Planning Commission Staff Report
Council Chambers
June 5, 2018 1:30pm

7. APPLICATION: Farmstead | Preliminary Development Plan

Project Number: 201712270044

Site Plan

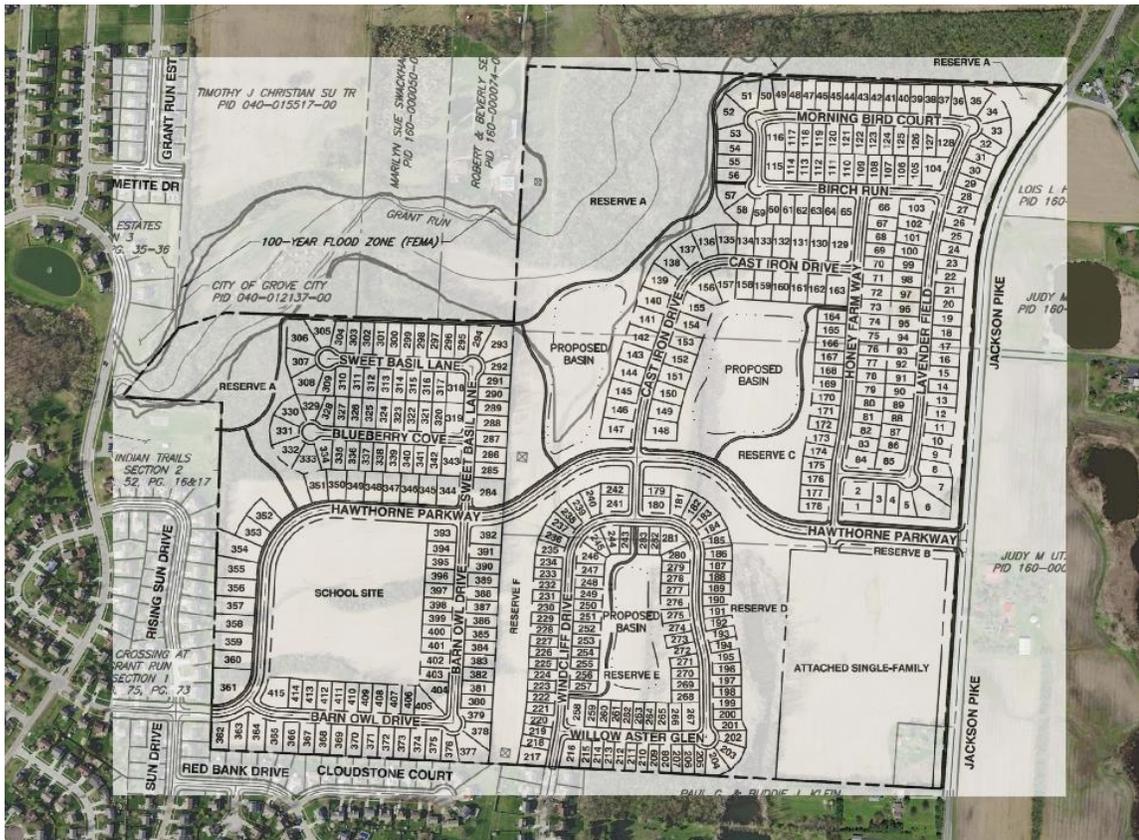
The 208-acre site is proposed to have three (3) points of access, with two (2) points through an extension of Hawthorne Parkway from the Indian Trails subdivision to Jackson Pike, and a third from the extension of Windcliff Drive. Hawthorne Parkway will remain 32 feet in width with an 80-foot right-of-way as is currently existing and will be widened with a median at the Jackson Pike intersection, which is proposed to be signalized. Separate subdivision streets, including Windcliff Drive, are proposed off Hawthorne Parkway which will be 28 feet in width with 60-foot right-of-ways and will access each of the subareas. Approximately 19 of the proposed homes will be permitted driveway access onto Hawthorne Parkway, across from the school site, creating a similar street character found in the majority of the Indian Trails subdivision. Both the extension of Hawthorne Parkway to Jackson Pike and the connection to Windcliff Drive are shown on the GroveCity2050 Community Plan Transportation Improvement Map. According to the plan, the Hawthorne Parkway extension is recommended to be a Neighborhood Connector, which are meant to connect neighborhoods with more heavily traveled roadways.

There are nine (9) subareas proposed with seven (7) detached single-family subareas (A through G), an attached single-family subarea (H), and a proposed school site (I). Proposed single-family lot widths range from 50 feet for the cottage-style homes in Subarea C to 80 feet for the Manor homes in Subarea B. Subarea H is proposed to have attached single-family homes with 30-foot minimum lot widths. A layout of Subarea H has not yet been submitted and will be reviewed as

A variety of sidewalks and paths are proposed on the site. Sidewalks at 4 feet in width are proposed along both sides of each street, unless another path type is proposed, and will connect into the existing sidewalks on Hawthorne Parkway and Windcliff Drive. Shared use paths, either 4 feet or 6 feet in width, proposed to be constructed of concrete, asphalt, mulch, or grass are proposed through the site's reserves and will connect different sidewalks and bike paths, including connecting to the existing Indian Trails Park just west of the site. An 8-foot bike path is proposed along the north side of Hawthorne Parkway and along the west side of Jackson Pike, further connecting the city's bike path network.

Six (6) reserve areas (A through F) are proposed throughout the site, encompassing approximately 67-acres and providing space for two (2) detention ponds, trails, existing tree stands, and other recreational uses. Portions of Reserves A and F are within a 150-foot electric utility easement and portions of Reserve A are within the 100-year floodplain, both of which are located on the western portion of the site. Discounting the portions of open space in the floodplain

A preliminary stormwater management report, stormwater plan, and utility plan were submitted as part of this application and will be reviewed in more detail with the final development plan; however, preliminary review of the stormwater data has raised concerns on the amount of stormwater diversion across the property. It is recommended that another stormwater basin be located in the eastern portion of the site. Staff will work with the applicant during the final development plan review to determine an appropriate location for this pond, potentially as part of an entrance feature at Hawthorne Parkway and State Route 104 in Subarea H.
